**ADDENDUM 1  
TO THE CONTRACT PROVISIONS AND CONTRACT PLANS**

**CITY OF QUINCY  
NEUTRALIZED BRINE WASTE CONVEYANCE SYSTEM**

**G&O #18030**

**ISSUED THIS DATE: THURSDAY, DECEMBER 6, 2018**

**ENLARGEMENT DETAIL 4 (STA 44+68)**

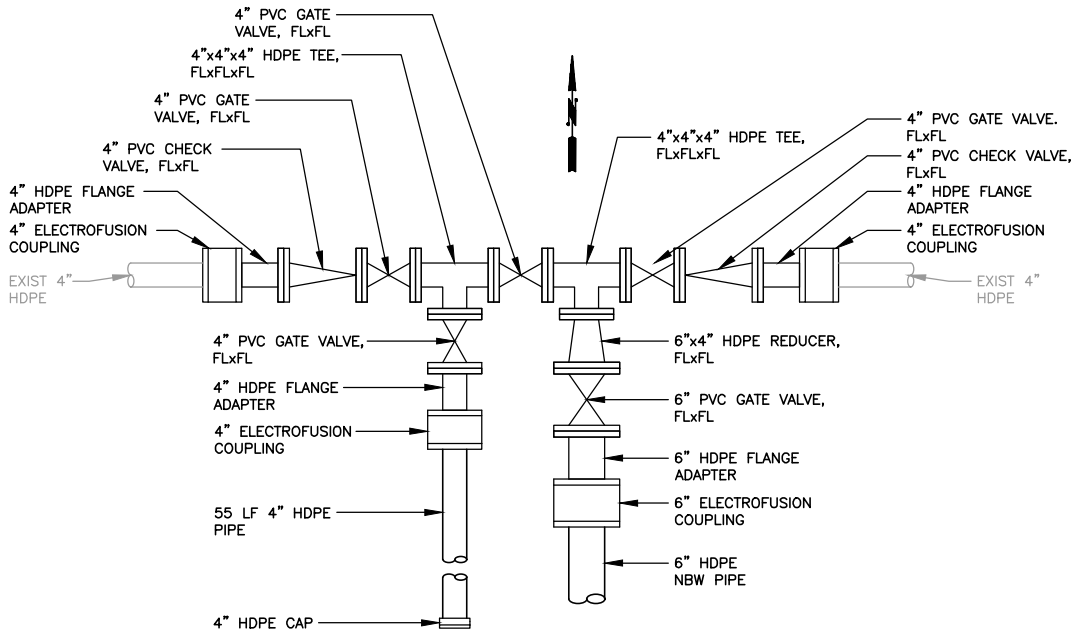
**SHEET 15, ENLARGEMENTS & MISCELLANEOUS DETAILS**

**DELETE** ENLARGEMENT DETAIL 4 (STA 44+68) and **REPLACE** it with the attached Addendum Drawing No. 1.

1. EXISTING 4" HDPE HAS APPROXIMATELY 6- FEET OF COVER FROM SURFACE TO TOP OF PIPE.
2. EXISTING 4" HDPE IS DIPS, DR17.
